Arboriculture Impact Assessment Report

**Site Assessment Conducted and Report Prepared by:
The Tree MD Pty. Ltd. Geoffrey Ashton AQF 5 in Arboriculture**

**Hastings Secondary College Port Macquarie Campus
Owen St Port Macquarie NSW**

42

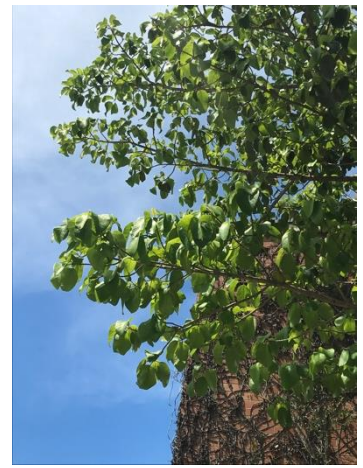
Crown lifting of northern and eastern
branches 400mm Final cut

Flexible final pier location for
shelter, grade adjustment cut at top
at top of ramp is outside of SRZ
however will need non-invasive
assessment.
